SEB Issue List Regarding APR 1400, FSAR 3.4.2 “Analysis Procedures”

Issue #1 (AI 3-79.1)

Issue #2 (AI 3-79.2)

Figure 1

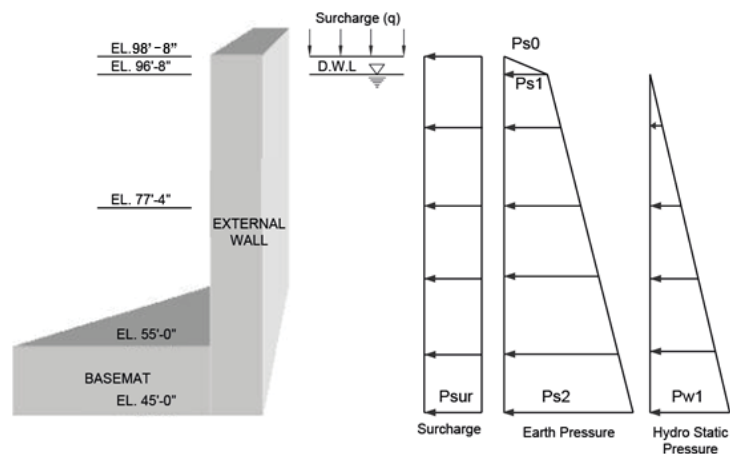
- b. How are those various water heads transformed into hydrostatic or hydrodynamic loadings (including buoyant forces)? [such as hydrostatic load, (L_h), Flooding load, (Y_f), Design flood/precipitation, (H), PMF/PMP, (H_s). Hydrodynamic load in seismic loads (E_s)—See Sec. 3.8.4.3. and Table 3.8-9A, Footnote (2)]

- b. How are those various water heads transformed into hydrostatic or hydrodynamic loadings (including buoyant forces)? [such as hydrostatic load, (L_h), Flooding load, (Y_f), Design flood/precipitation, (H), PMF/PMP, (H_s). Hydrodynamic load in seismic loads (E_s)—See Sec. 3.8.4.3.and Table 3.8-9A, Footnote (2)]

Soil and Surcharge loading is calculated as a linearly distributed pressure on the external walls depending on the design water level (EL. 96'-8") according to the basic equation of hydrostatics as shown in Figure 1.
